Field Service Bulletin Trucks

Battery Starter Lug Failure
CXU, GU

FSB 371-045, Battery Cable Lug, Failure

(July 2013)

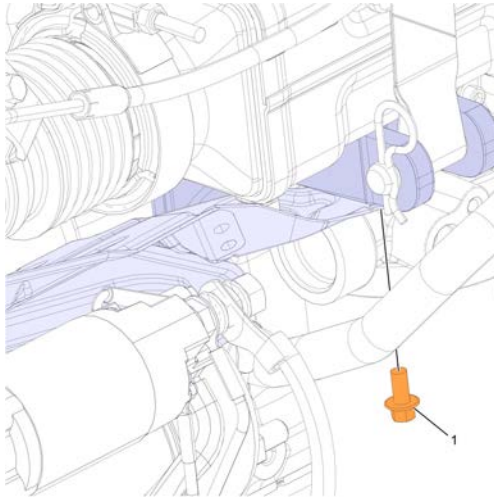
Certain vehicles built from January 1, 2010 to June 14, 2013 with a MP7 engine may experience cracking or breaking of the 90 degree positive battery cable lug at the starter solenoid stud. In some cases, the lug is bent during assembly, and along with engine vibration may cause the terminal to weaken and fail over time.

To support the cable and eliminate this failure, follow the procedure below:

W2080360

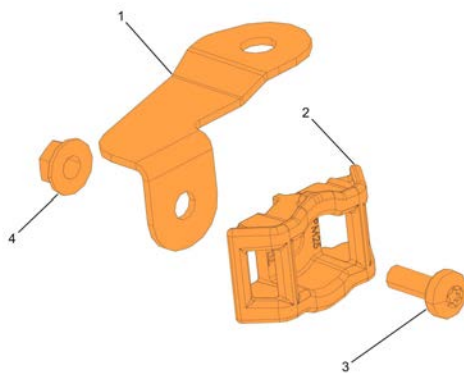
- 1 Secure the vehicle for service by parking it on a flat level surface, applying the parking brake, chocking the rear wheel, and placing the transmission in neutral.
- 2 Disconnect all cables from the negative (ground) battery terminals to prevent personal injury from electrical shock and prevent damage to electrical components.
- 3 Remove the fastener from the heat shield bracket.

W2080361

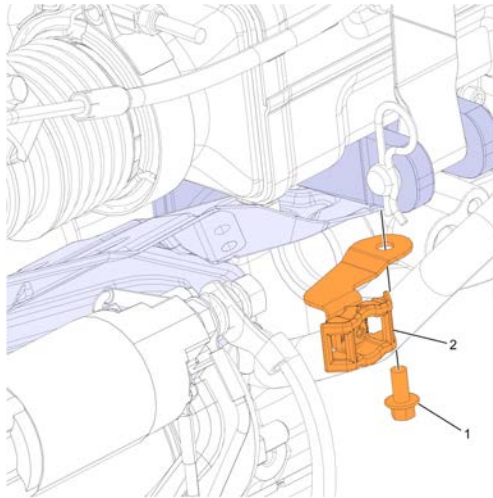
- 4 Preassemble the bracket and the saddle.

W2080362

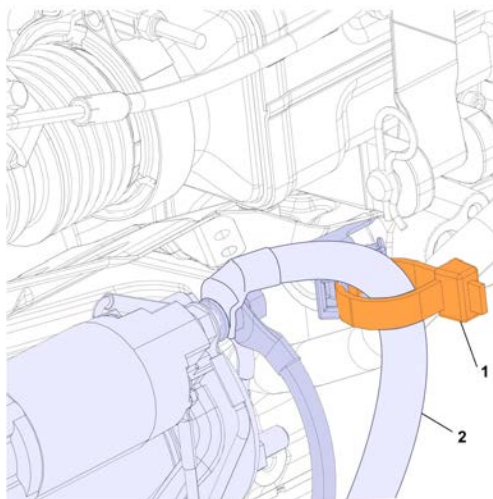
- 5 Install the bracket onto the vehicle and secure.
